Mitigation Plan  
Banner Branch Mitigation Project  
Stokes County, North Carolina  
FINAL VERSION

NCDEQ DMS Project Identification # 100080  
NCDEQ DMS Contract # 7610 and # 7701  
Roanoke River Basin (Cataloging Unit 03010103)  
USACE Action ID Number: SAW-2018-01760  
Contracted Under RFP # 16-007405  
DWR Project # 20181154

Re: NCIRT Review and USACE Approval of the NCDMS Banner Branch Mitigation Site /  
Stokes Co./ SAW-2018-01760/ NCDMS Project # 100080

**SUBJECT:** Banner Branch Mitigation Site - NCIRT Comments during 30-day Mitigation Plan Review

SHEET NAME  
**UT4-R1**  
 PLAN AND PROFILE  
 SHEET NUMBER  
**13**

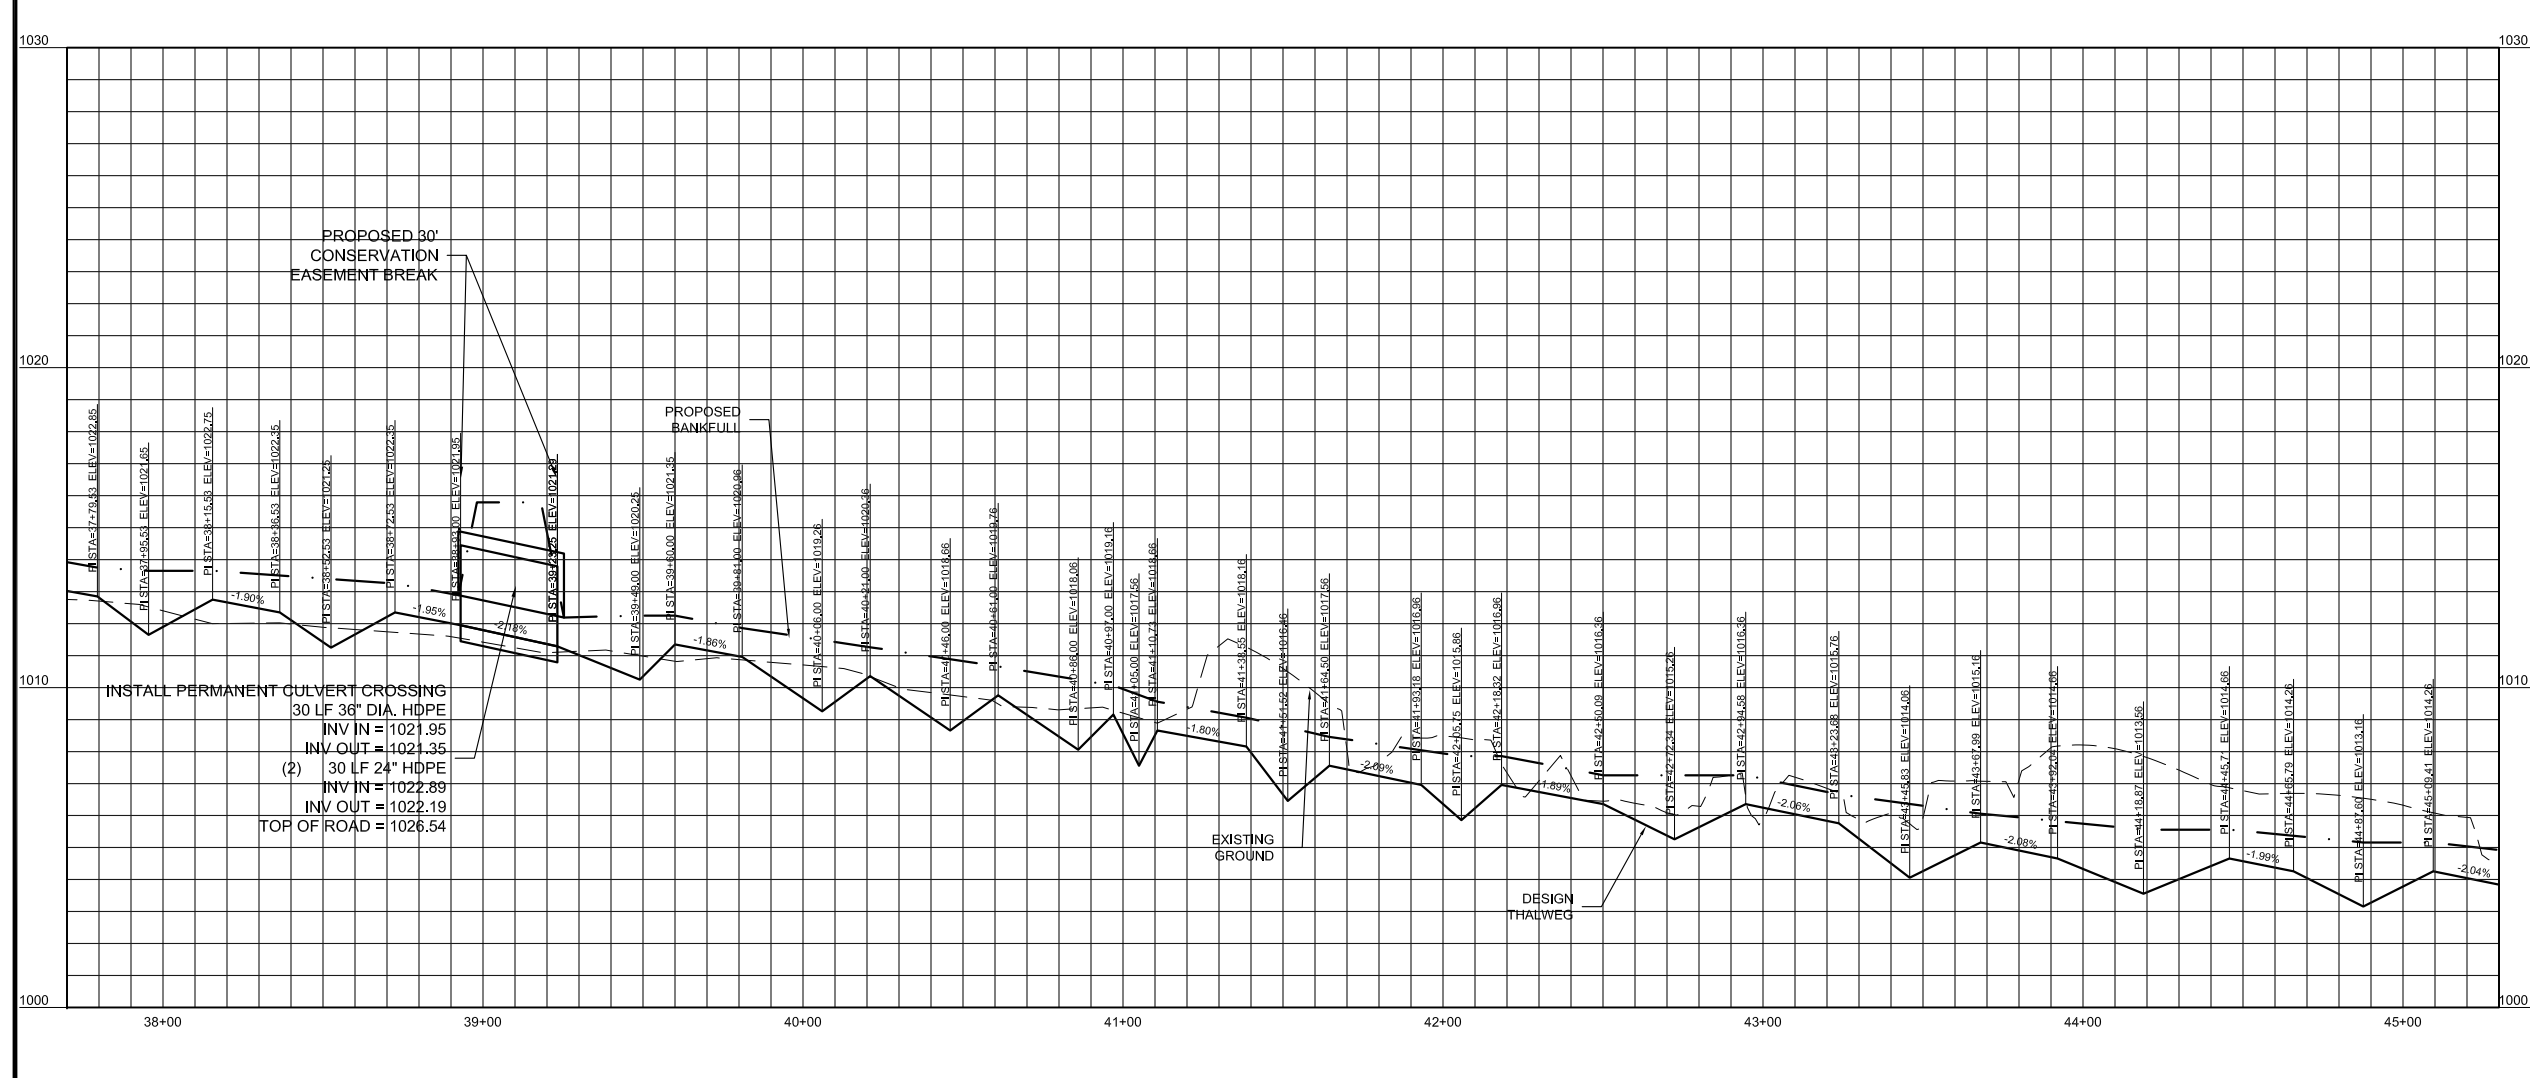
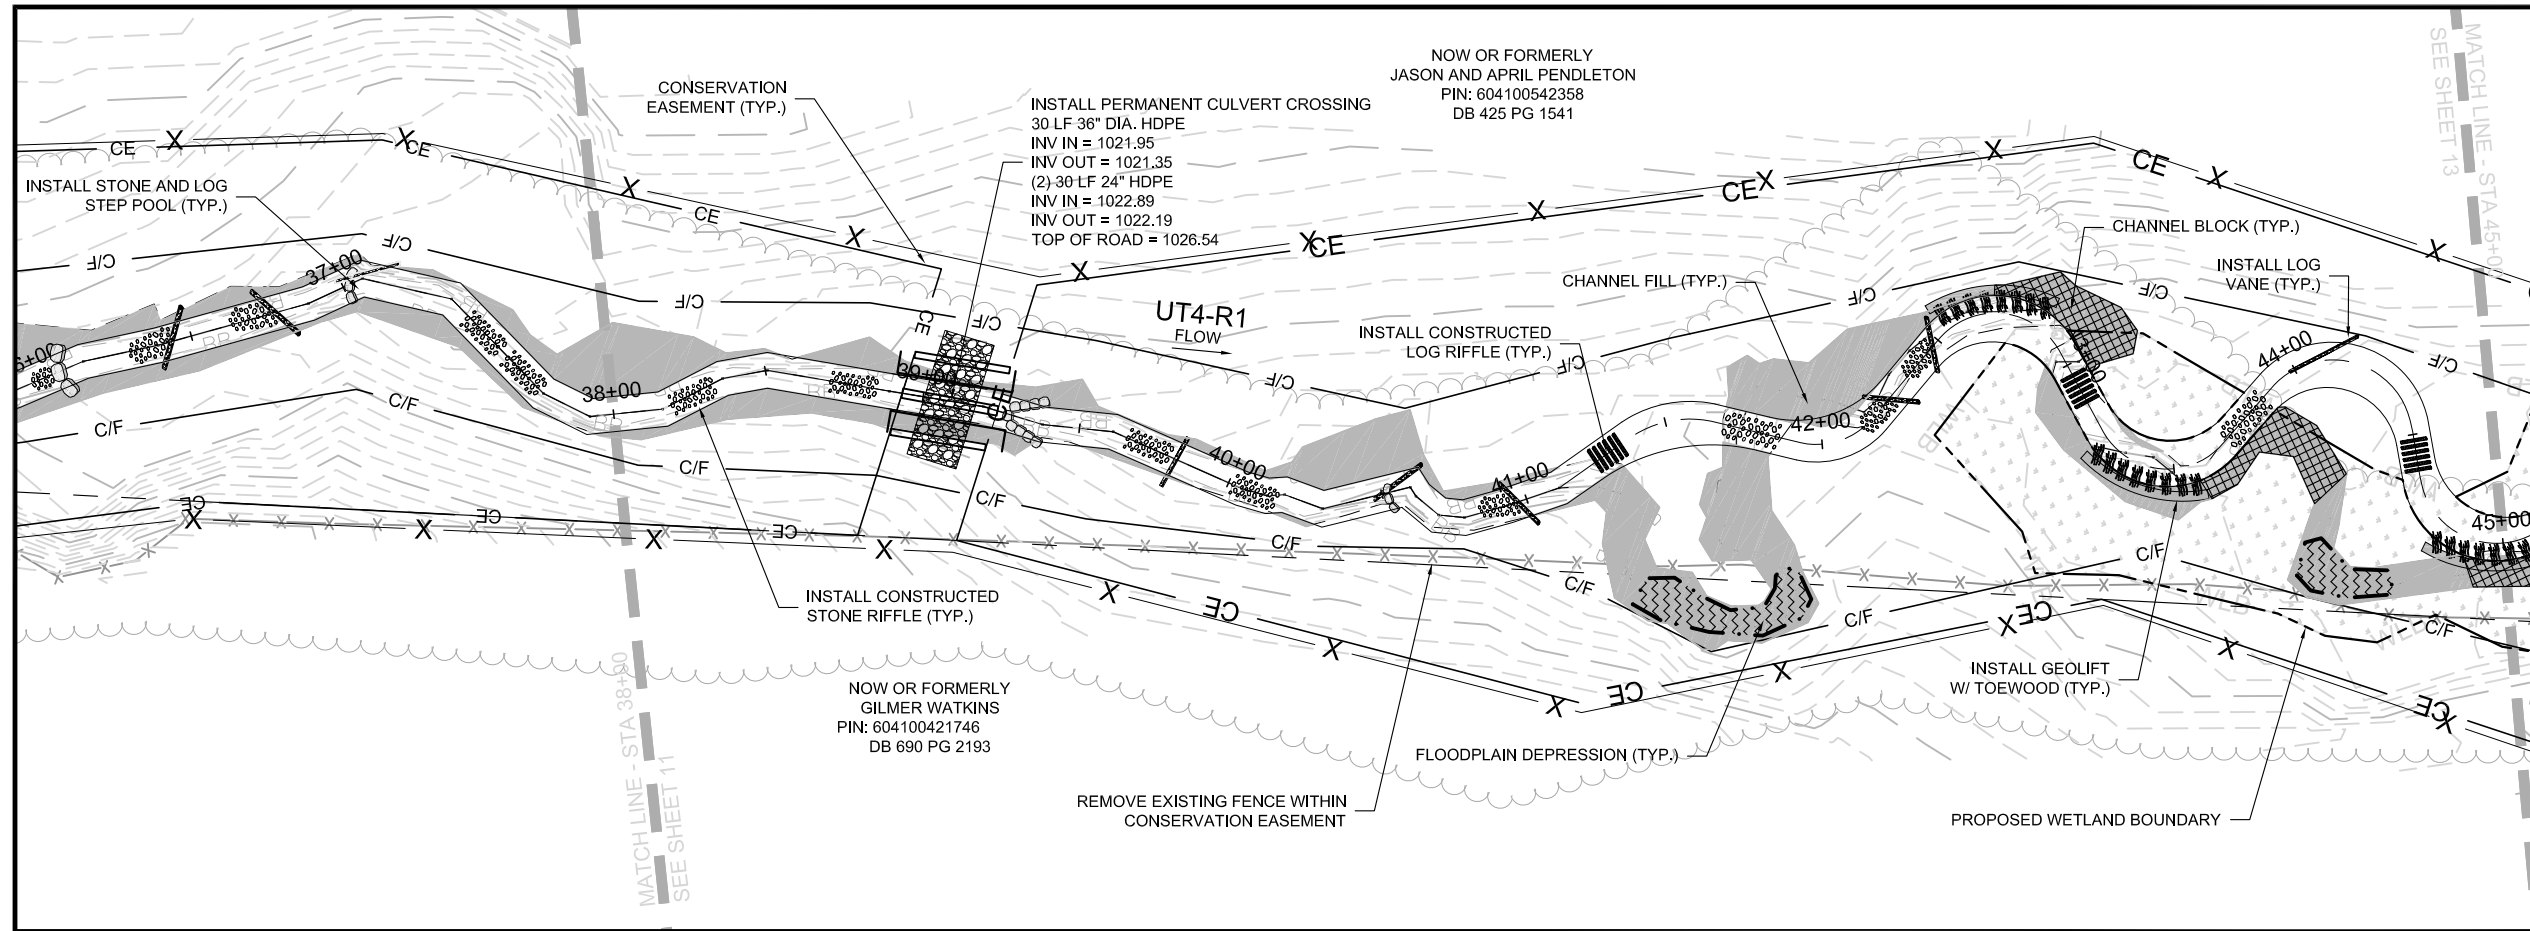
24. Sheet 13 – Please confirm the profile callouts for existing ground and design thalweg are indicating the correct features.
25. Sheet 15 – The CE crosses the southwest corner of the existing pond. Please show how this area will be graded within and immediately adjacent to the CE line.

**24. Sheet 13 – Please confirm the profile callouts for existing ground and design thalweg are indicating the correct features.** Response: WLS has revised sheet 13 profile callouts and confirmed other sheets have correct profile callouts as well.

SHEET NUMBER  
**14**

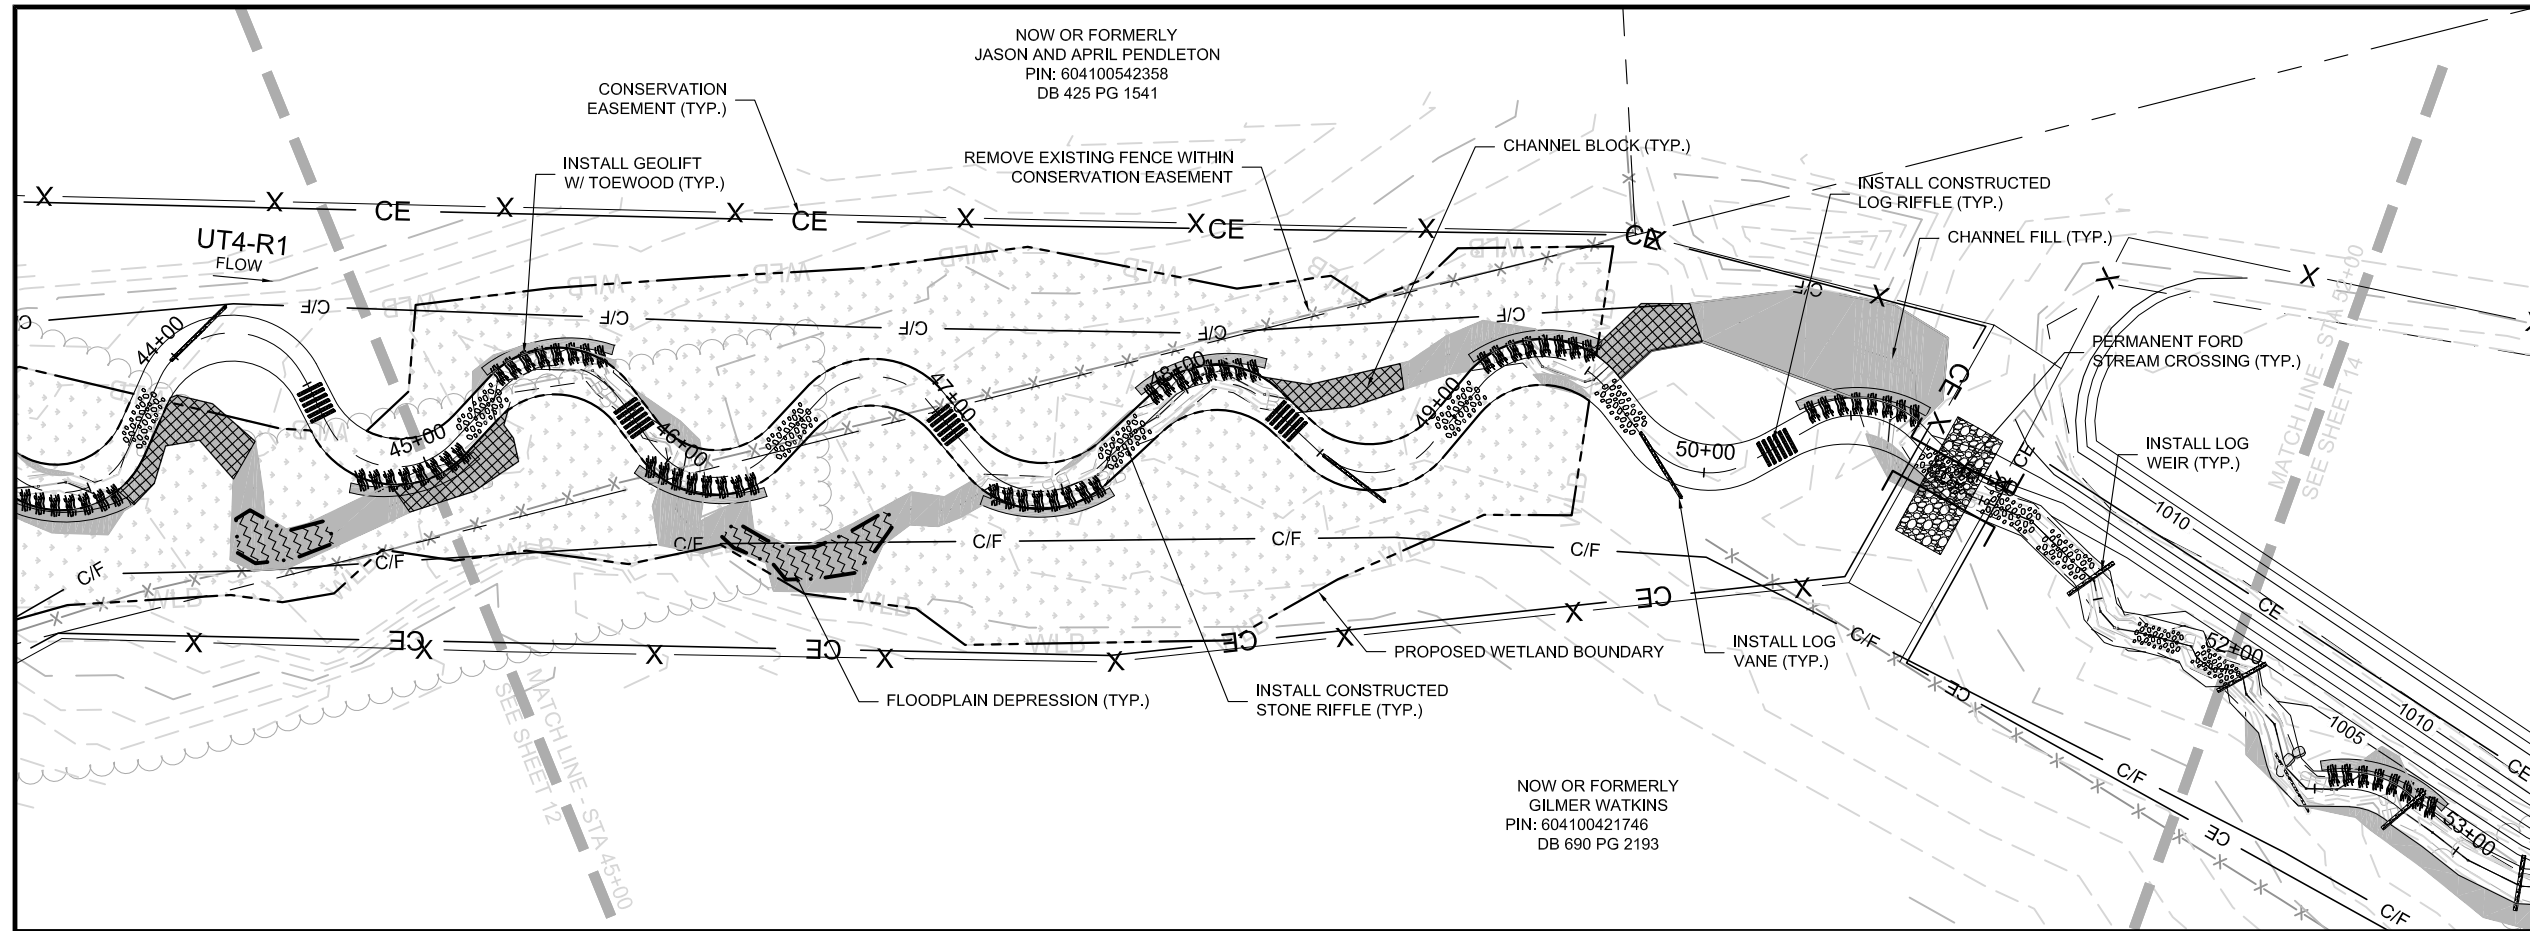
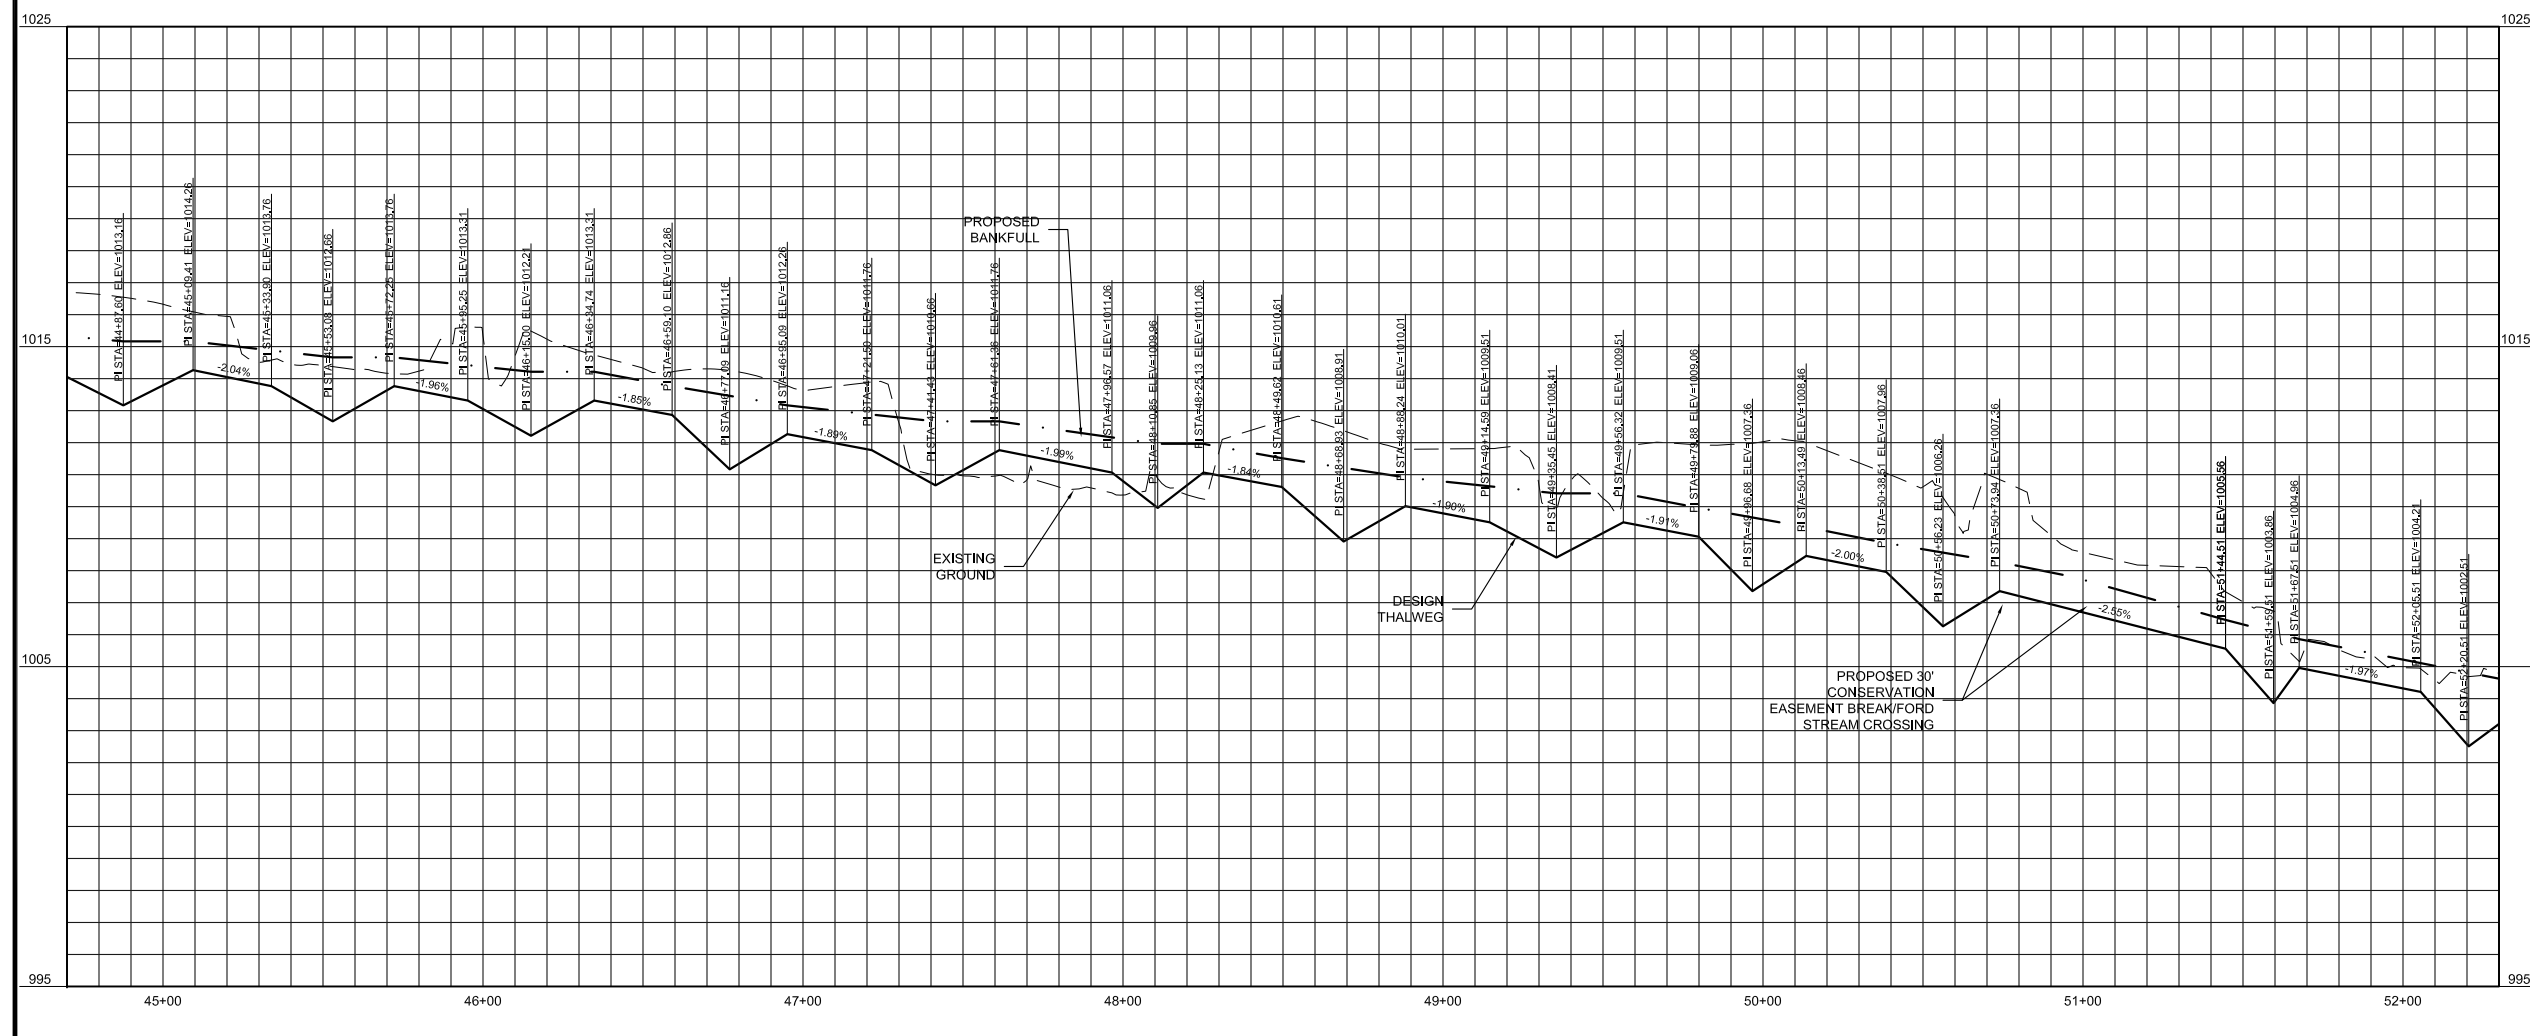
21. Sheet 3 – DWR recommends that benches be at least two times bankfull width for C type stream restoration.
22. Sheets 14, 23 & 33 – Please callout stream crossings/easement breaks on the profile views.

**22. Sheets 14, 23 & 33 – Please callout stream crossings/easement breaks on the profile views.** Response: Stream crossings/easement breaks have been noted in the profile views.
